**To:** Greg A. Wayne  
**From:** Nicole Smith, Associate Planner; 910-341-1611  
**CC:** File;  
**Date:** 6/17/2020  
**Re:** Airlie View, Formerly Robert Holding Subdivision

■ **AIRLIE VIEW- Formerly ROBERT HOLDING SUB-DIVISION [SUBDIVISION Plan Review #3]**

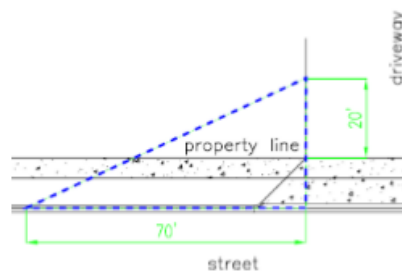
1. Awaiting the Auto Turns Movements for the Turnaround between Lot 3 and Lot 4.
2. No Further Comments.
